BEFORE THE VARIATION 2 HEARING PANEL

Variation 2 to the proposed
Second Generation Dunedin City
District Plan (2GP)

STANTEC NEW ZEALAND – RESPONSE TO SUBMITTER EVIDENCE

Dated 31 August 2022

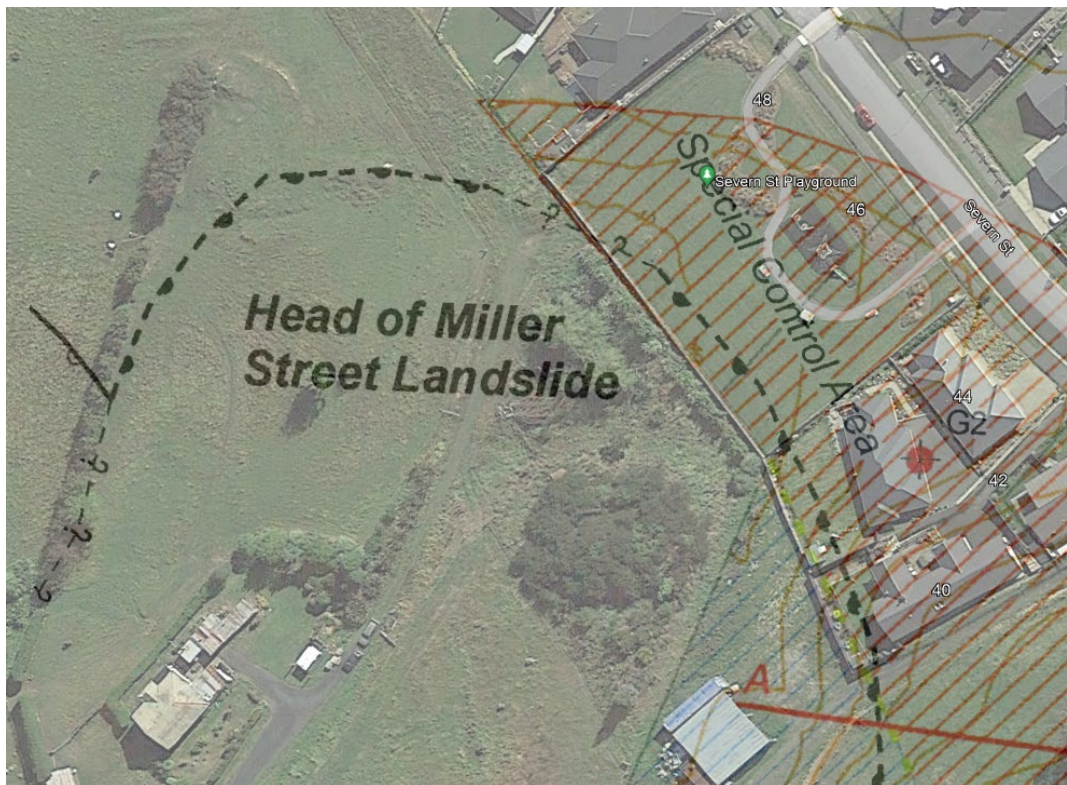
38. **GF05a and gully feature:** We are left conflicted after reading the advice regarding the gully feature and the Miller Street landslide. There appears to be consistent sentiment that the Miller Street landslide and gully feature is at “low risk of land instability” and feasible for residential development. Then in contrast, consistent comments throughout the report appear to the contrary. Here are four such comments:

Particular emphasis on geotechnical advice should be applied to any proposal for residential development on land steeper than 15 degrees or within the gully area/Miller St landslide shown approximately on Figure 6. These areas may be better suited to reserves, however with sufficient engineering and acceptance of risk, some areas such as these could be considered for development.

The test pit that was excavated in this area (TP 11), shows less favourable geotechnical conditions than elsewhere on the property (e.g. softer soils, slickensides and groundwater at 1.6 m depth). This is consistent with landslide terrain.

40. In our opinion, all of the above comments are a strong indication that the site is not appropriate for rezoning. These comments would be appropriate in support of a subdivision or land use consent application for constructing a dwelling on land that is already zoned correctly, but not for a new rezoning.

41. We recommend that land should not be rezoned into a situation where Section 72-73 encumbrances are even a consideration, or where dwellings would need to be designed for creep and maintenance to prevent cracking.

44. In summary, after a more detailed study into the history of the site and some concerning comments in Geosolve's report, we do not support increased density rezoning of any land within the Miller Street landslide complex. We do acknowledge that some areas of the site are more suited for increased density, outside the Miller Street landslide and gully features.
